RE: PROJECT - NW CORNOR OF COORS BLVD & ST. JOSEPH DR. (COORS PAVILION) – ALBUQUERQUE, NM. 87120.

PROJECT NUMBER: 10000032, APPLICATION NUMBER: 17-70001

ADMINISTRATIVE AMENDMENT TO SITE DEVELOPMENT PLAN FOR BUILDING PERMIT TO ADD AN OUTDOOR PATIO

Sheet Title:
Landscape Plan

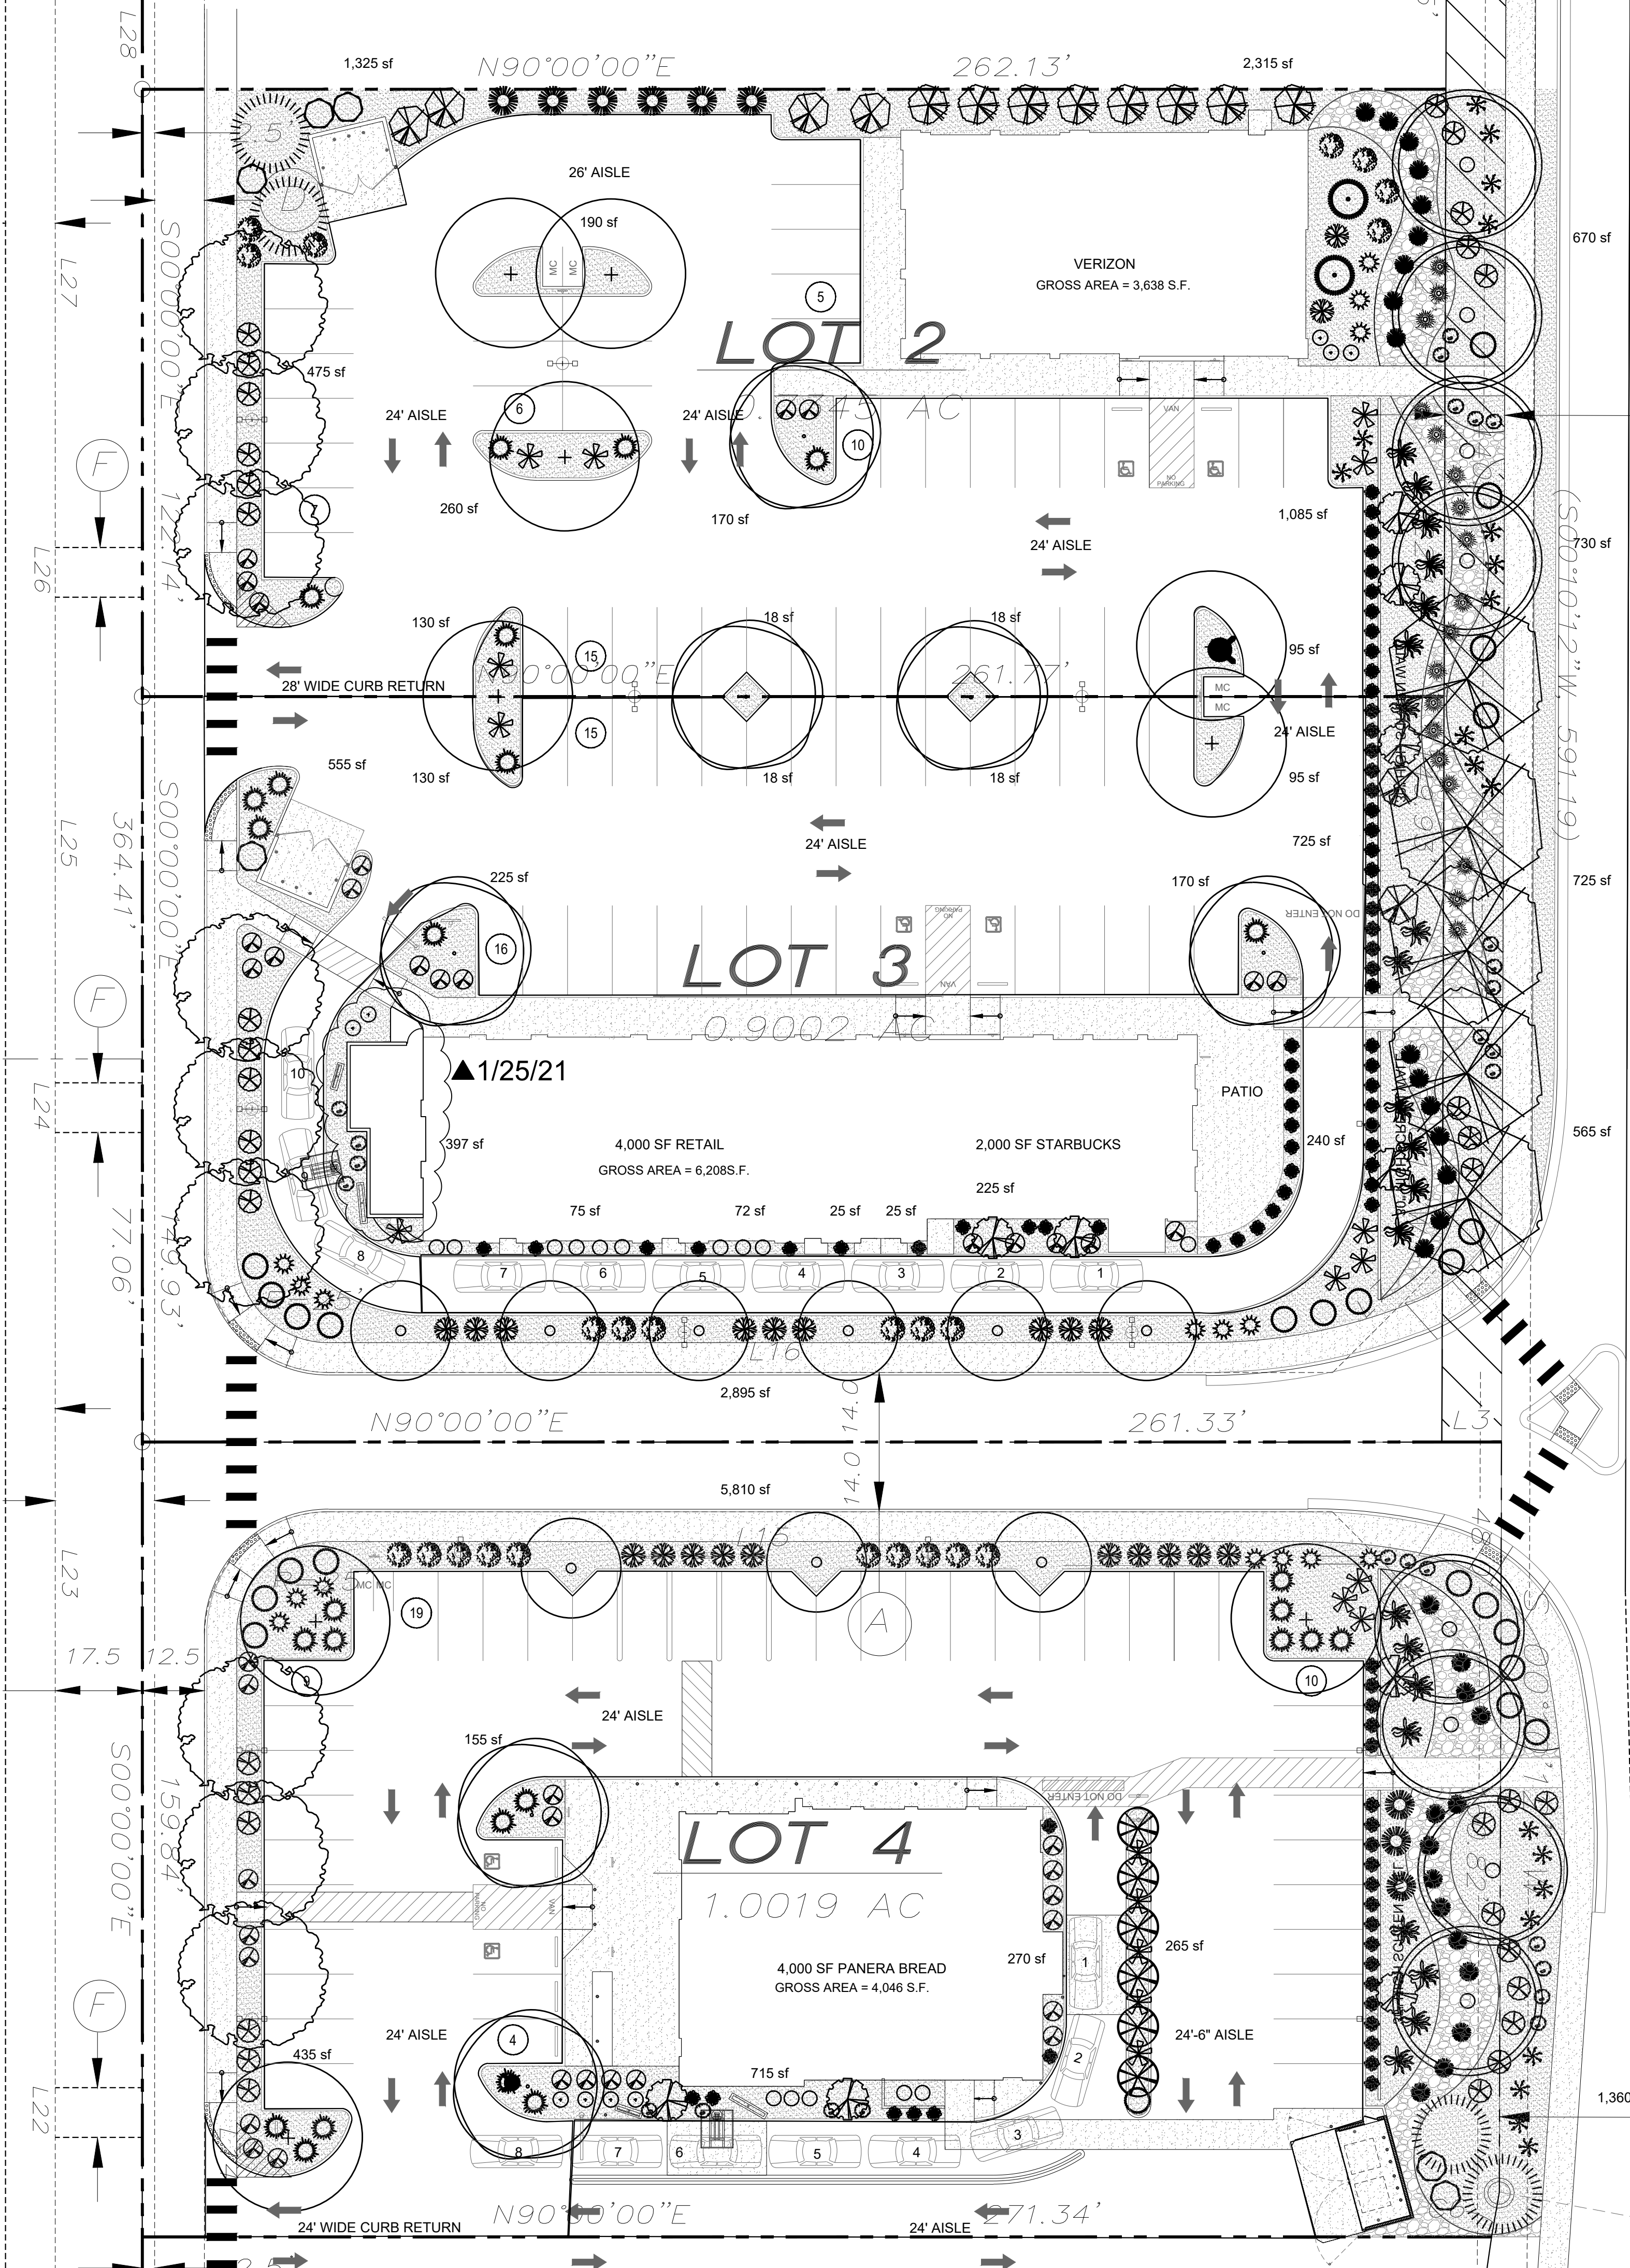
1. A landscaping plan has been modified to accommodate the required outdoor patio.
